SERVICE BULLETIN

Service Bulletin SB-T-04-1500B-0002

RDR-1500B WEATHER RADAR SYSTEM

PRODUCT IMPROVEMENT TO ENHANCE HIGH VOLTAGE RELIABILITY

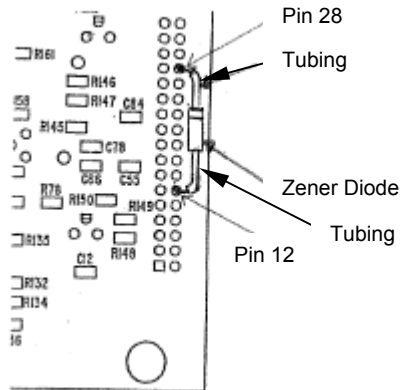
A Zener diode is added to the Video/RS-170 Module.

- a) Attach two pieces of teflon tubing to the Zener diode and solder the diode to the board as shown below. Be sure to observe that the polarity band is positioned as shown.
